Service Bulletin

Bulletin No: 2006-2-01

Subject: Clutch Cover Cap Screw/Ground Cable

All 2005 650 H1 LE ATV's

Fig. 1

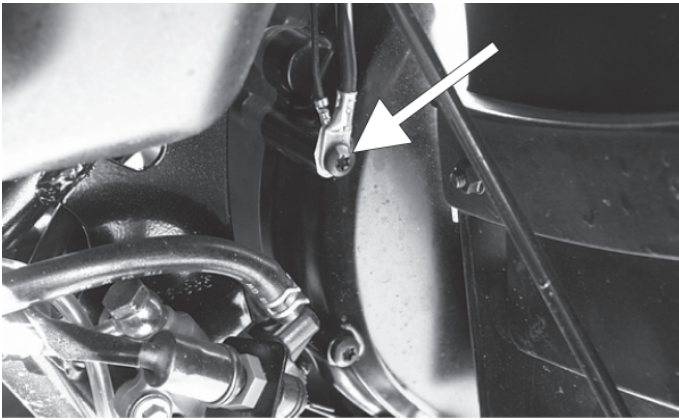
Condition: It has been determined that the cap screw securing the ground cables to the clutch cover may not be adequately grounded. If this condition exists, the ATV may not start. Damage to other ATV components may also occur if the ground is transferred to other ATV components.

■ **NOTE:** The cap screw in question was inadvertently coated with a non-conductive material which may prevent an adequate ground.

Solution: Remove the cap screw (see Fig. 1) securing the ground cables to the clutch cover. Remove both ground cables from the cap screw; then reinstall the cap screw in the existing hole. Tighten to 1.1 kg-m (8 ft-lb). Remove the cap screw located one screw above the screw that originally secured the ground cables. Discard the existing cap screw. Secure both ground cables to the clutch cover at this new location using new Cap Screw (p/n 8470-645). See Fig. 2 for new mounting location of ground cables. Tighten to 1.1 kg-m (8 ft-lb).
